Determination 2012/025

Compliance of barriers to a bridge located on a former film set at 501 Buckland Road, Matamata

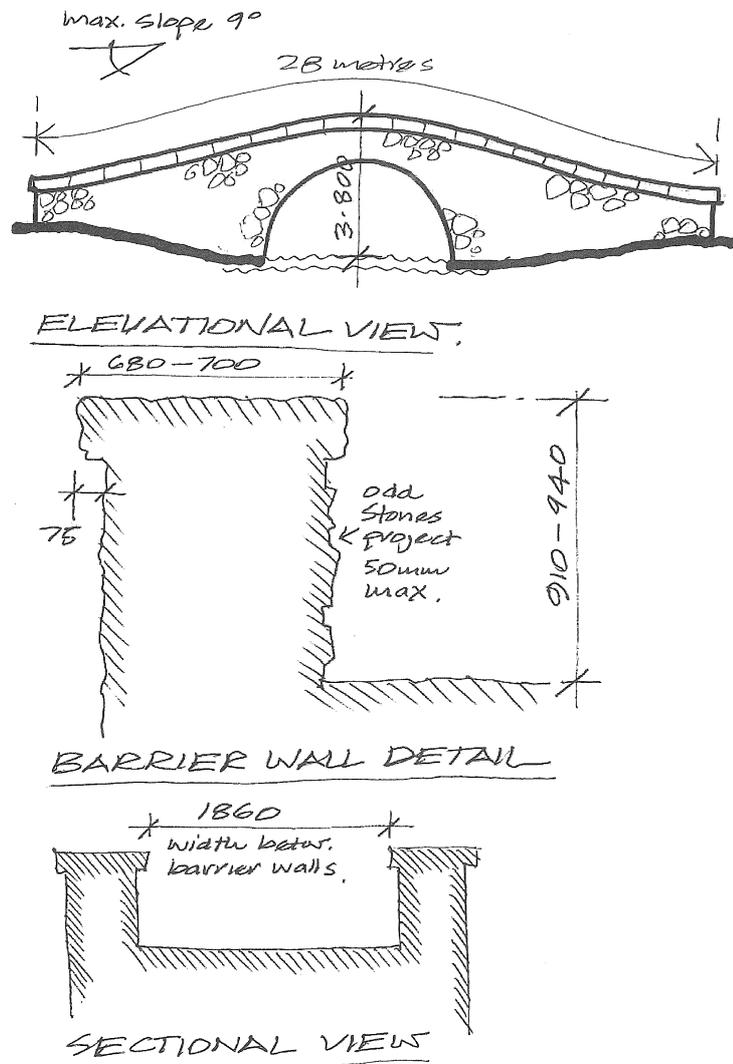
2.4 The bridge was largely constructed in accordance with the consented plans. It is 28m long and 1860mm wide between its barrier walls, sloping gradually from ground level to its midpoint at 3.8m above the lake water level. The maximum slope of the bridge is 9°.

2.5 The bridge barriers, as built, are faced and capped in stone. Due to the capping stones used being thicker than planned for, the barriers are higher than shown in the plans, ranging between 910mm and 940mm. The tops of the barriers are 680mm to 700mm wide, and have an overhang of 75mm.

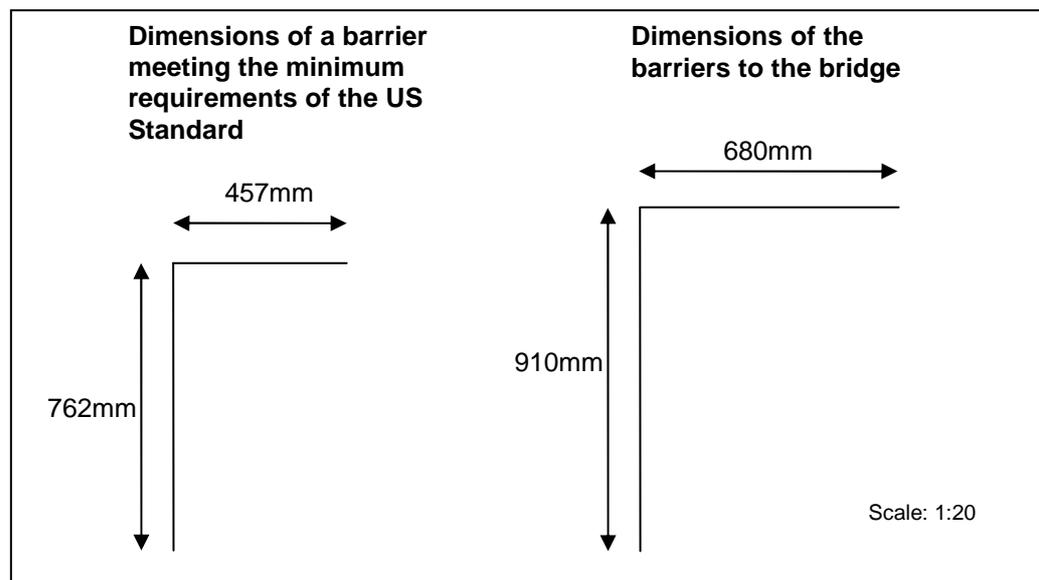
5.4.9 The bridge barrier is between 910-940mm in height and 680-700mm in width. Using the criterion in paragraph 5.4.8, with a barrier width of 680mm the corresponding minimum barrier height is 539mm as follows:

However, according to the US Standard, the minimum height regardless of barrier width, is 762mm. As the height of the bridge barrier is 910mm (at its minimum), it therefore complies with the US Standard.

5.4.10 I also note the given the US Standard minimum height of 762mm, the criterion used in paragraph 5.4.8 can also be used to determine the minimum barrier width as follows:

The as built width is 680mm, and therefore exceeds the minimum 457mm dimension set by the US standard.

- 5.4.11 The following sketch demonstrates the bridge barrier compared to the minimum barrier allowed for in the US Standard:

- 5.4.12 Accordingly, for the reasons I have described in paragraphs 5.4.1 to 5.4.11, I consider that the barriers, as built, are of an adequate height and comply with Clause F4.3.4(b).
- 5.4.13 I note however, that the width of the top of the barrier provides a platform that, in my view, increases the possibility that people could sit, and possibly stand or walk along its flat top, which requires consideration of whether this configuration complies with Clause F4.3.1 of the Building Code. I discuss this aspect of the barrier in paragraph 5.6.
